Inspection of Automatic Sprinkler System

BW1 Seraphim Solar East London
Industrial Development Zone

UNC.8476

09.05.2024 08:00 SAST

Photo 10

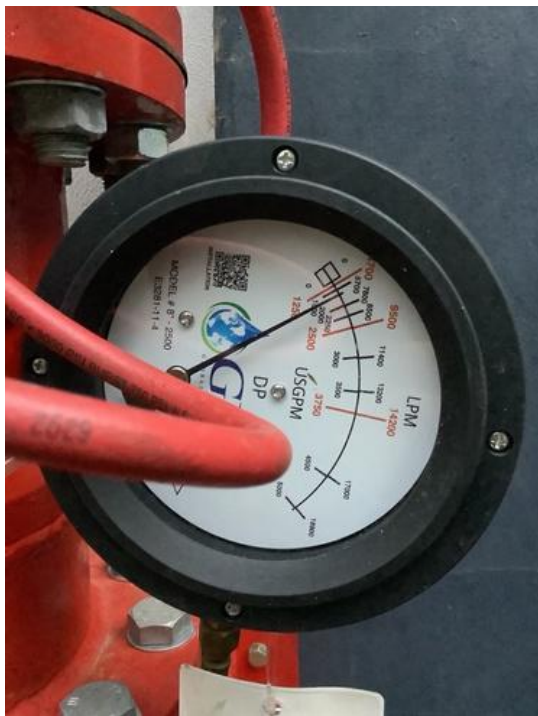
It appears that the booster connection piping to the main distribution riser is too long, which may restrict the opening of the booster plunger into the main distribution riser, this will prevent effective boosting of the sprinkler system and must be revised.

Installations must be fitted with fire brigade booster connections which will enable the fire brigade to pump water into the installation using their own equipment.

Photo 17

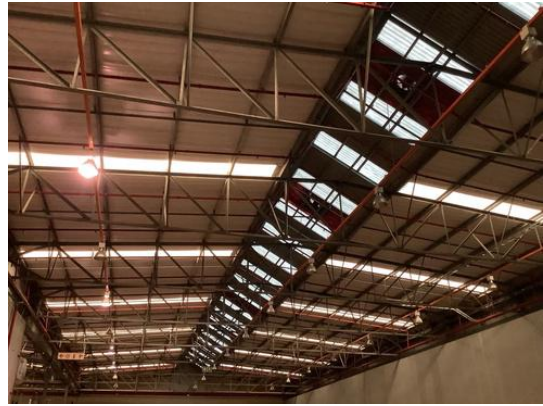
The maximum roof angle of 9,5 degrees for effective ESFR protection appears to have been exceeded, this must be investigated and addressed by your installer.
